RE: COMPLIANCE SUBMISSION (NO. 3) IN RELATION TO LIDL DISCOUNT FOODSTORE ANCHORED DEVELOPMENT AT MAIN STREET UPPER, NEWCASTLE, CO. DUBLIN

SOUTH DUBLIN COUNTY COUNCIL PLANNING REGISTER REFERENCE: SD22A/0312

2.0 RESPONSE RE. BUILDINGS C+D WINDOWS TO HISTORIC FAÇADES

Proposed external windows (facing Athgoe Road, existing building heritage façade).

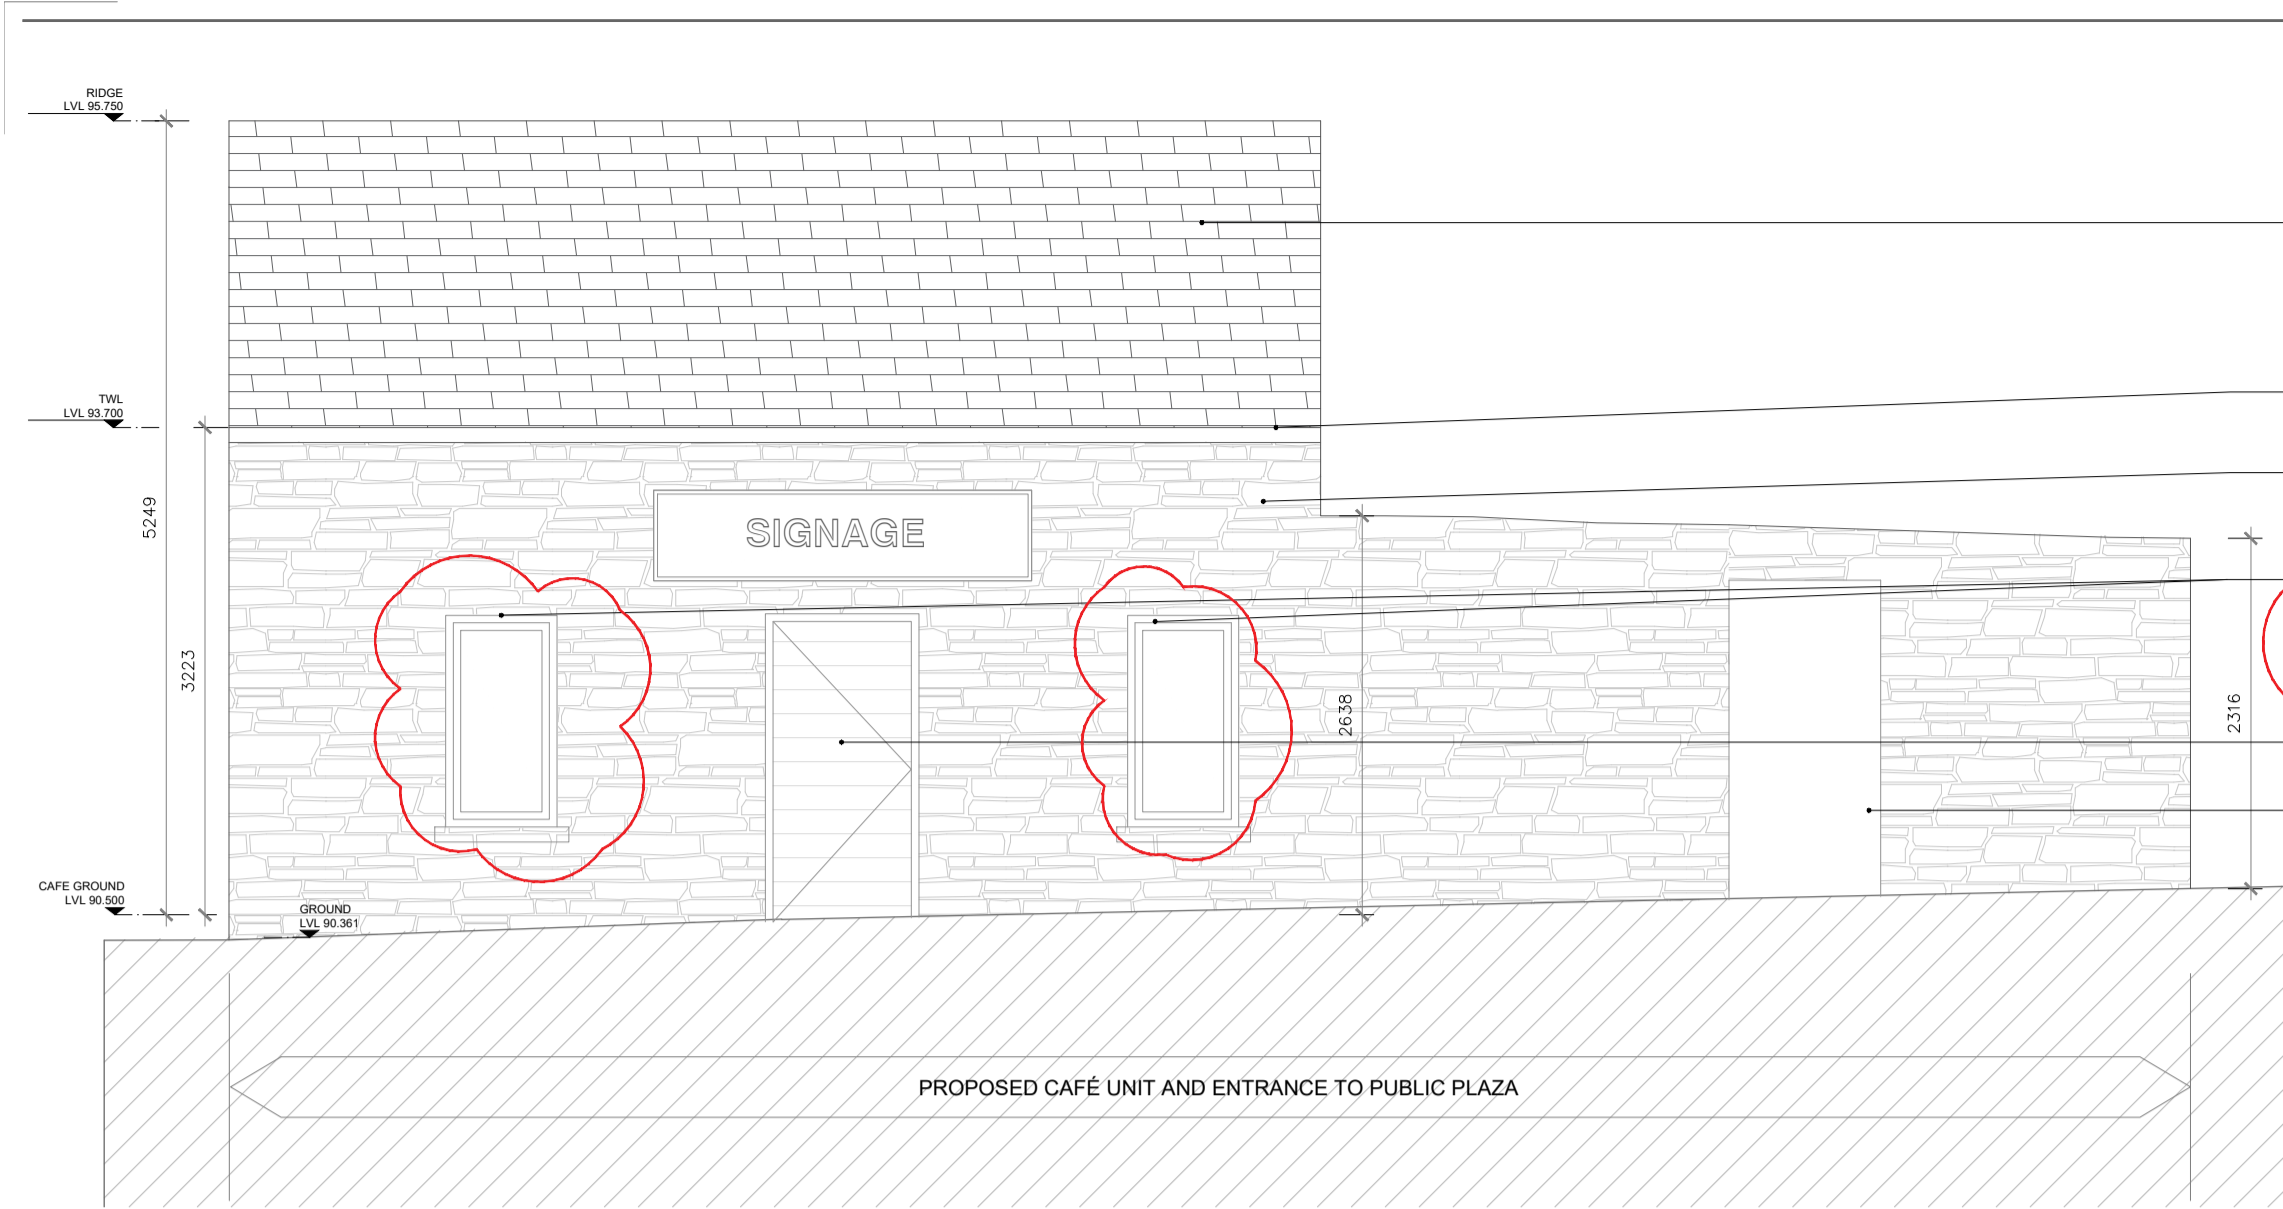
There was just one item that I would like to seek further clarification on and that is the new sash windows proposed to the historic building façade. It is important that if historic window types are to be reinstated that this is done with windows that will match the original profile and material type to ensure they are historically correct and so that you don't end up with a thick unit and window that looks small and reduces natural light. The finish colour should match in with the colour palette and therefore the sashes should be painted in a dark colour rather than white as shown. I would argue however that if there is no evidence of the window type at this location that modern windows could be considered to tie in with the overall design of the Café/retail unit and Buildings C+D). I would therefore advise that this item is addressed or clarified.

Aluminium frame windows-double glazed coated aluminium coloured grey RAL 7024 (dark grey) to achieve min 1.20 (W/m²K) u-value with stone cills.
